SERVICE BULLETIN

No. SB-NG-1-24

Subject: Canopy-Placard

Aircraft affected: EXTRA NG: S/N NG002 through NG064.

Fig. 1: Canopy placard – initial design

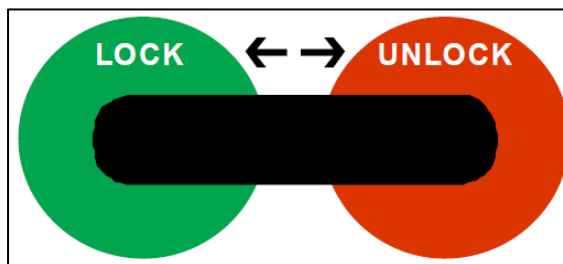
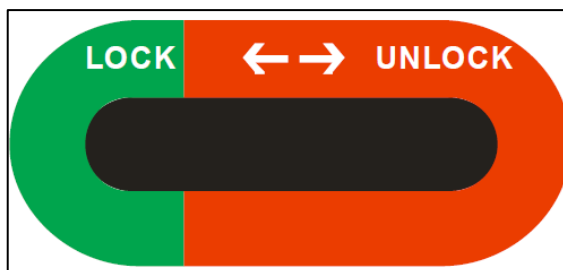
A design change of the canopy placard around the cutout for the movable (rear) canopy locking handles (1) in both cockpits was already introduced as an alternative, improved means of visualization of the canopy locking condition. EXTRA decided that the improved canopy placard should be the only version to reduce the misuse of the canopy locking and thus to avoid a potential unsafe condition. For that purpose all placards of the initial design (applied to canopies up to serial n° 071) shall be replaced by the improved version (2).

1. Remove canopy placards at both front and rear canopy handles. Clean area around cutout and remove all residue from old placard adhesive.

2. Install new canopy placards in current improved design as per Fig. 2 below:

Fig. 2: Canopy placard – current improved design
